# Read This First: Z-Active Differential Probes – Specifications Change & New Optional Accessory Tip

P7340A (4 GHz), P7360A (6 GHz), P7380A (8 GHz), P7313 (13 GHz)

## Medium Flex, Square Pin Tip-Clip Assembly

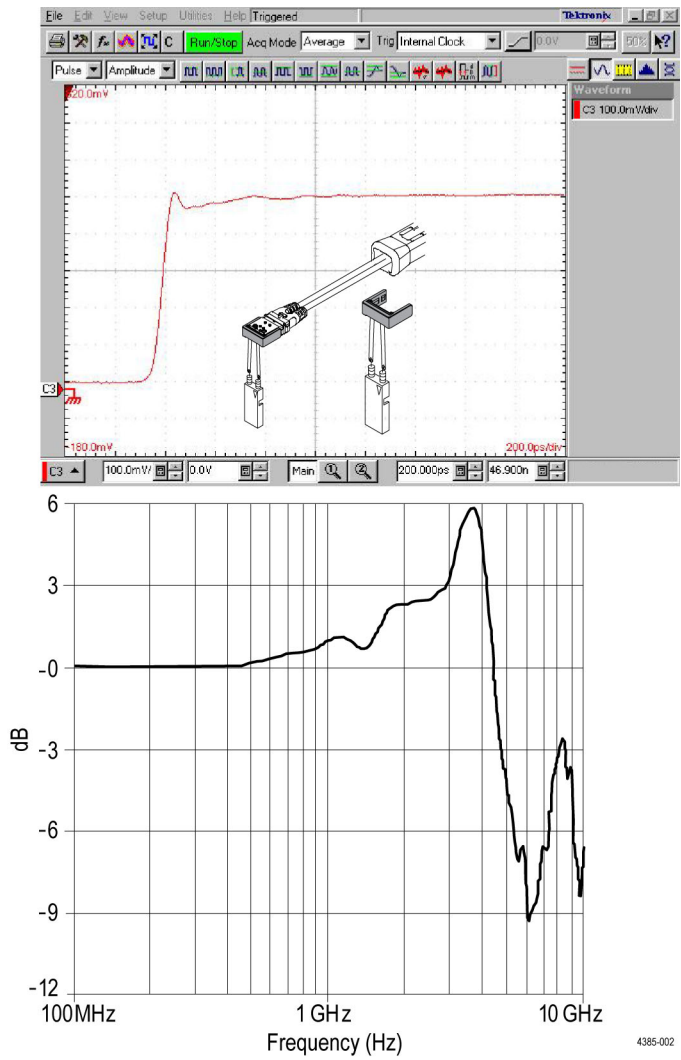
A kit of ten (10) Medium Flex, Square Pin Tip-Clip Assemblies are an optional accessory for the probes. The tips adapt your P73xx probe to 0.025 in. (0.63 mm) square pins that are spaced 0.10 in. (2.54 mm) apart. Order Tektronix part number 020-3116-xx, package of 10.

Refer to your probe manual for the installation procedure; it is similar to the tips that are included in the standard accessory kits.

Probe	Bandwidth	Rise time (10–90%)
P7340A	>4 GHz	<100 ps
P7360A	>5 GHz	<80 ps
P7380A	>5 GHz	<80 ps
P7313	>5 GHz	<80 ps
